## Historic Preservation Board Agenda May 27<sup>th</sup>, 2014 - 4:00 PM

# Certificate of Appropriateness

## HB 14-12

### 314 Madison St.

Figure 7: Asphalt architectural shingle roof

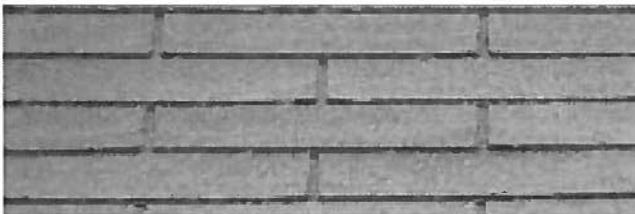
*Staff comment: It is not known what the original roof type was, however it was likely sheet metal or metal shingles. Other roof types utilized during the latter part of the 18<sup>th</sup> century included slate and wood shingles. Various sources, including the exhaustive St. Augustine Historic Architectural Guidelines indicate that asphalt shingles did not come into use until after the turn-of-the-century. St. Augustine allows the use of architectural shingles in medium to dark gray or brown colors only for Frame Vernacular buildings constructed after 1920 and also for all Masonry Vernacular buildings. Strictly speaking, the proposed roof material does not resemble the materials utilized at the time of this house's construction. This is most apparent in the visual effect presented by the texture of the proposed material, as shown in Figures 4-7 on the next page.*

*Laminated shingles are also heavier and more durable than traditional 3-tab shingle designs, which heightens the contoured visual effect. The view from Madison Street of roof areas of this house is quite extensive and will present a strong visual impact of a modern and textured roof which will stand in to the other preserved historic elements of this building.*

*Staff comment: Applicable provisions of the Secretary of the Interior's Standards call for replacing building elements with like kind. The original roof material is not known, but again in this case like kind would include metal, slate, and wood shingle roofing.*
